RE: **Lot 10 Block 5 Volcano Cliffs Unit 19 SAD 228**
6519 Azor Pl. NW
Grading and Drainage Plan
Engineers Stamp Date 3/8/2020 (D10D003H10)
Pad Certification Date 5/12/2021

Based upon the information provided in your submittal received 5/13/2021, this plan is approved for Building Permit.

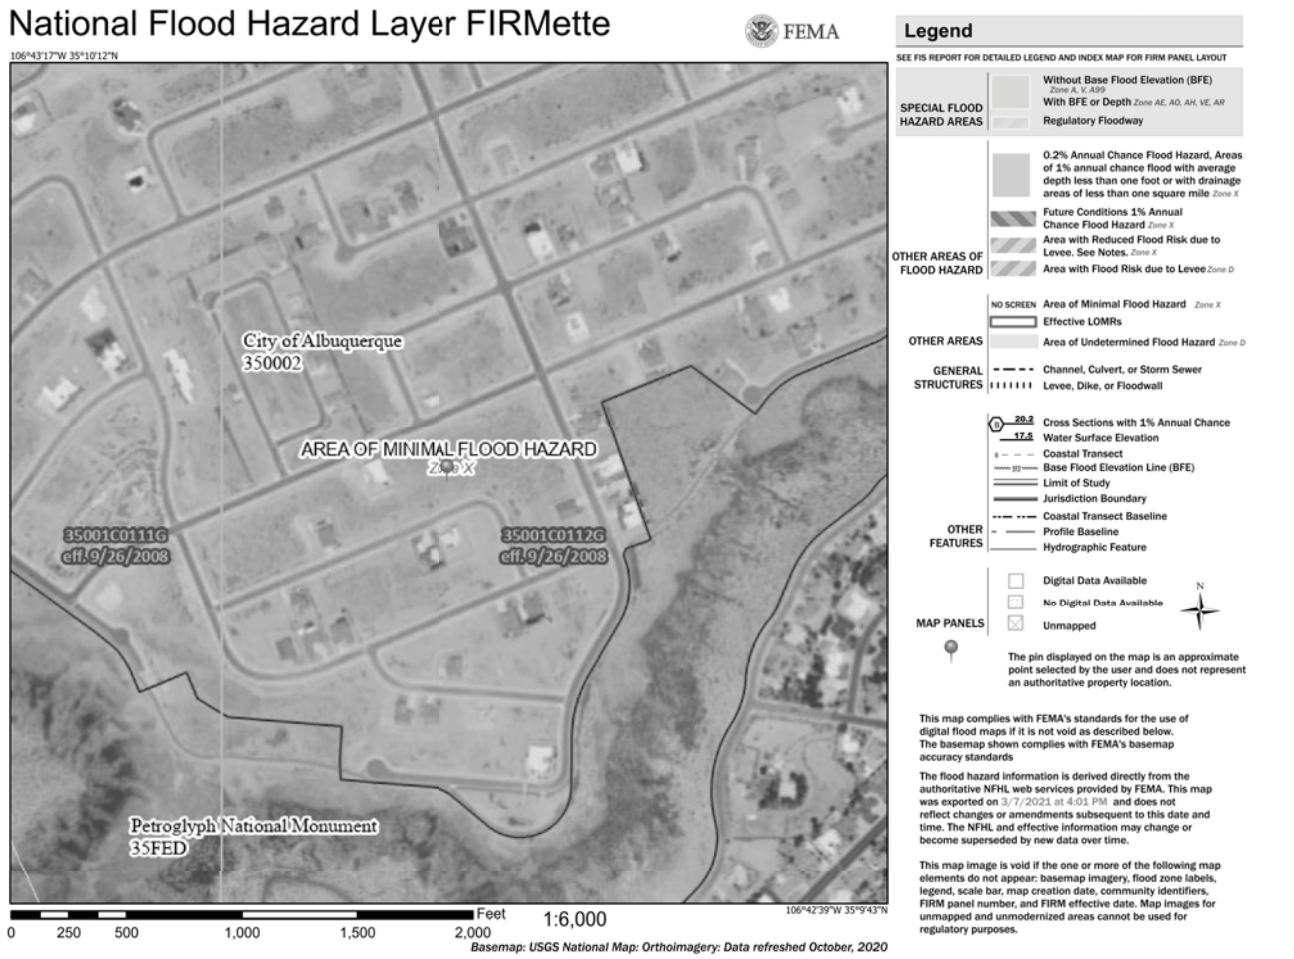
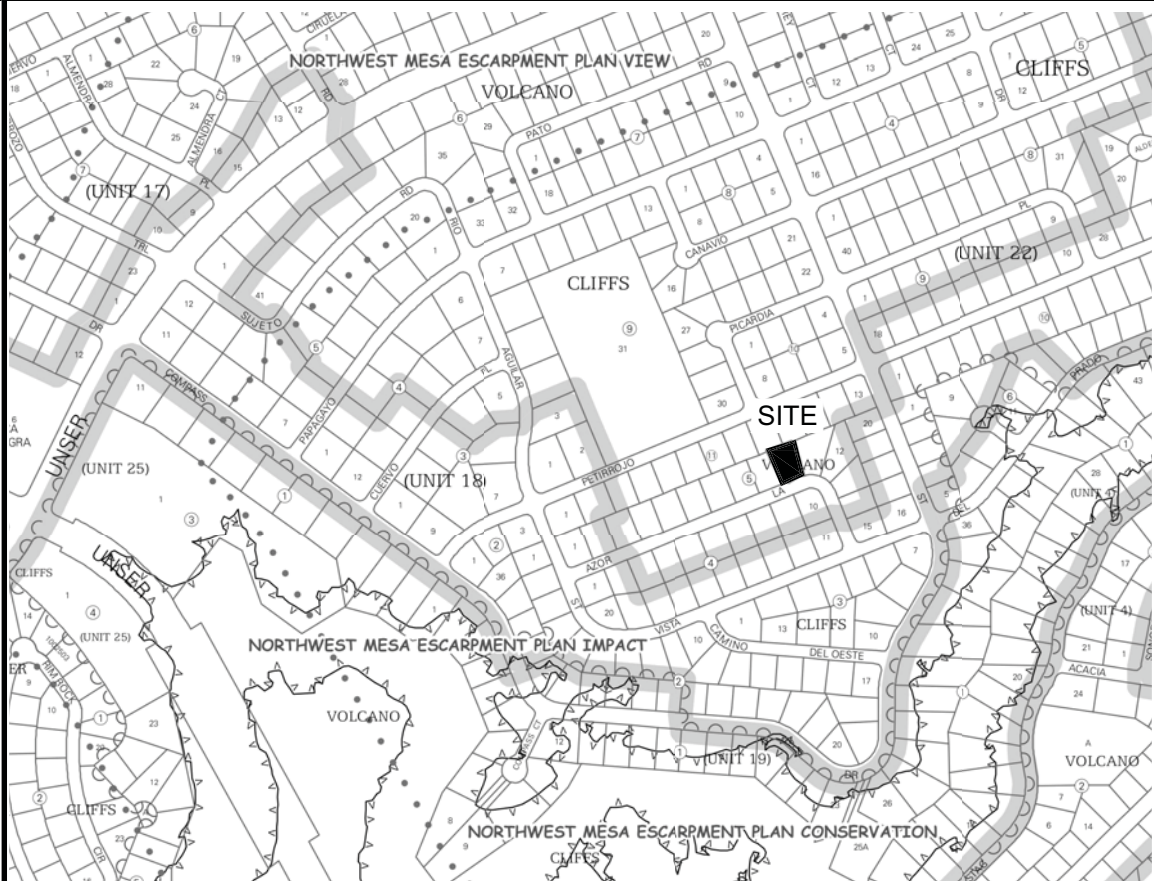
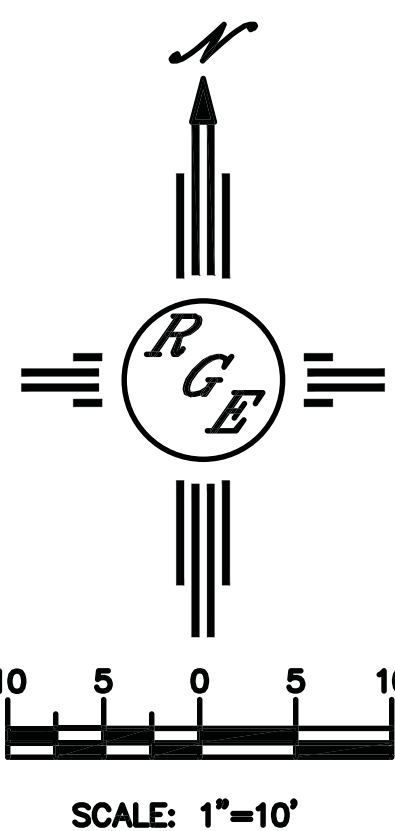
Reiterate to the Owner/Contractor that a separate permit for a garden/retaining wall must be obtained, with the approved G&D plan and Pad Certification. Also, let the owner/contractor know that if a pool is to be added in the future the G&D plan will need to be modified showing the location of the pool and the land treatment differences.

Prior to Certificate of Occupancy release, Engineer Certification per the DPM checklist of this plan will be required.
